A REPAIR

**ON-SITE SEWAGE DISPOSAL SYSTEM  
HOWARD COUNTY HEALTH DEPARTMENT  
BUREAU OF ENVIRONMENTAL HEALTH**

ADDRESS: 495 Morgan Station Road PROPERTY OWNER: Dale Murphy

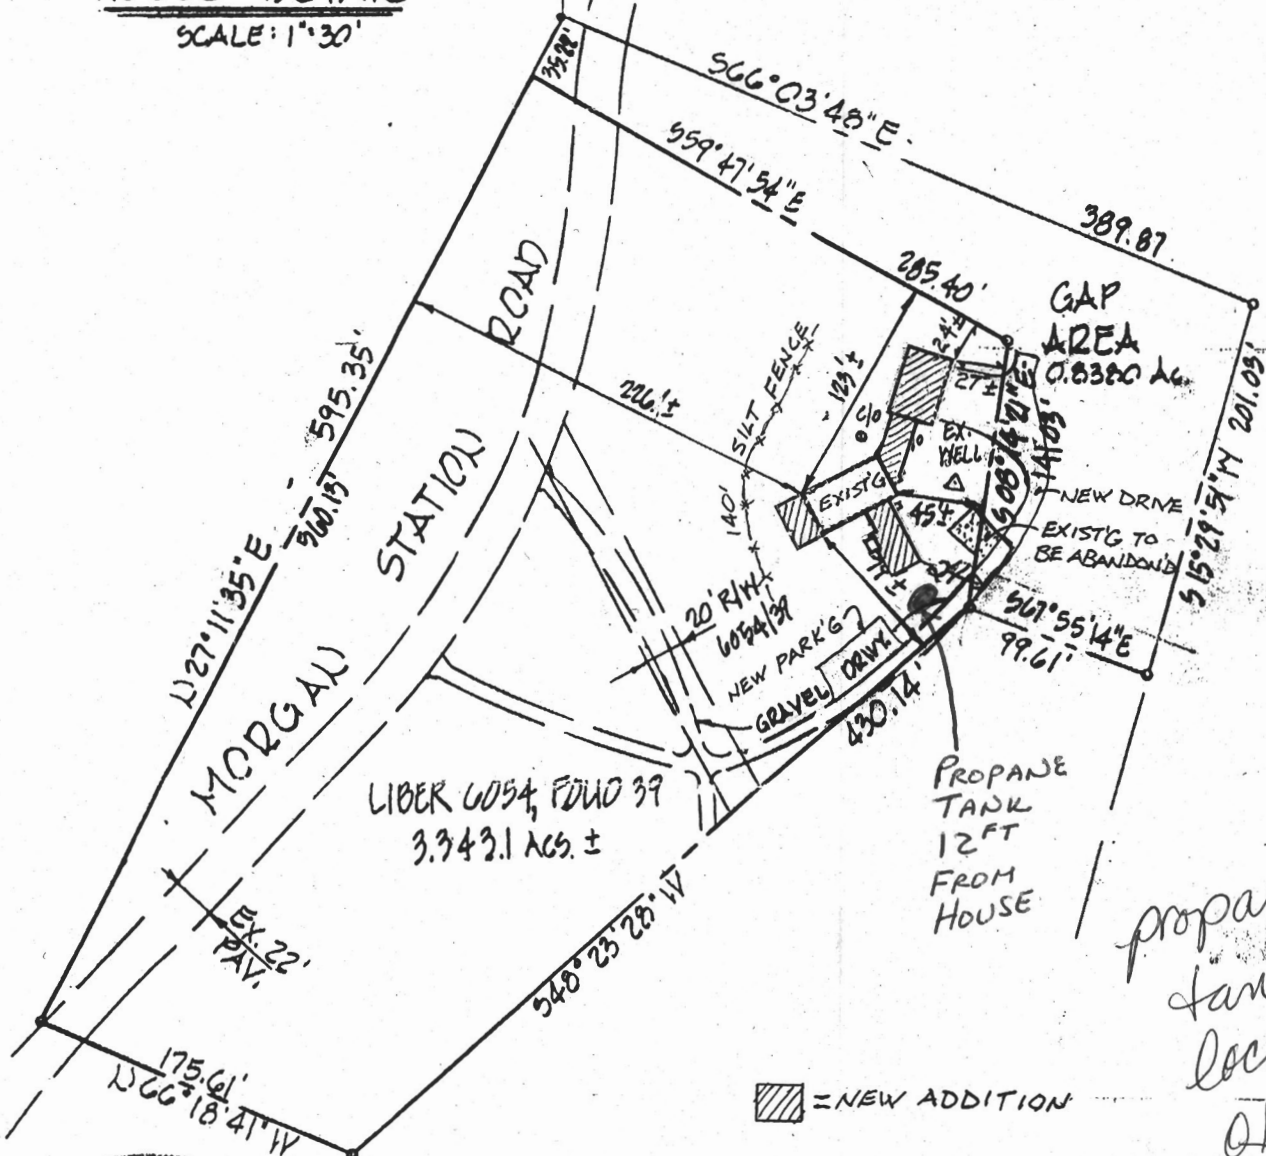
TRENCHES:	Trench to be 3 feet wide. Inlet 3 1/2 feet below original grade. Bottom maximum depth 5 1/2 feet below original grade. Effective area begins at 3 1/2 feet below original grade. 2 feet of stone below distribution pipe.
LOCATION:	Existing septic system is failing. Call for inspection when ground is opened. 20 90' ± TRENCHES DOWNHILL OF EX. D/W COLLAPSE D/W, REPLACE ALL PIPE
PURPOSE:	IN SUPPORT OF FUTURE BP ADDITION

INSTALLATION 7/10/02 D.W. collapsed & filled in. OK to cover all work (SC)
